Policy and Programmes

13 January 2026

STATUTORY CONSULTATION ON THE SOUTH EAST STRATEGIC RESERVOIR OPTION (SESRO) IN ACCORDANCE WITH S42 OF THE PLANNING ACT 2008

Figure 3-1 Groundwater conceptual model – pre-development conditions

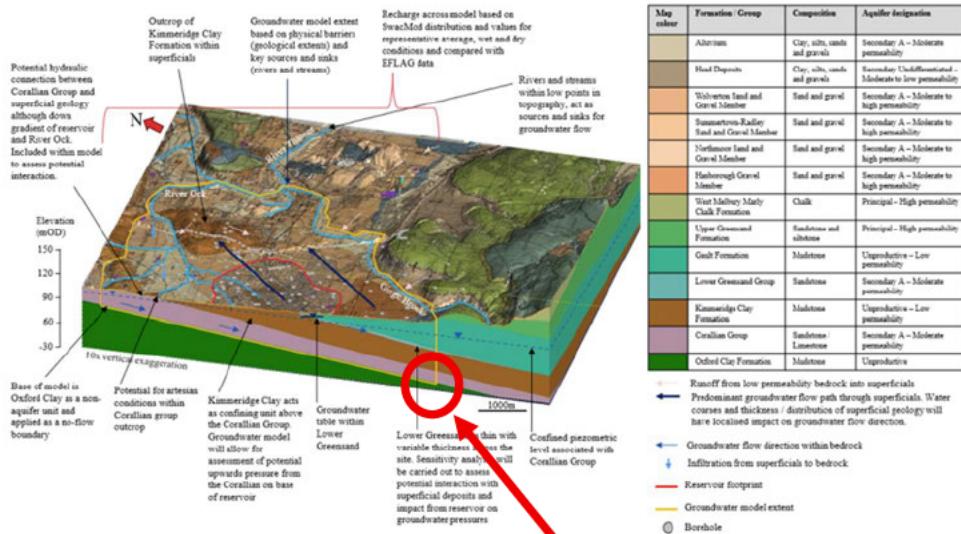
Based on Figure 3.1 and Paragraph 4.4.2 ‘... constant head boundaries will be applied to the model edge along the Corallian Group and Lower Greensand aquifers as they are considered a constant source of water within the model’.

As groundwater flow is indicated in Figure 3.1 as being downwards, towards this boundary, it would appear as if it will, therefore, act as a sink rather than a source and consequently may numerically remove water from within the groundwater model (and reduce modelled flood risk at the surface). If so, this may be difficult to quantify and be a potential source of numerical error. SODC expect this boundary (and others) to be independently checked using appropriate water budget calculations, to be presented as part of the model calibration exercise.
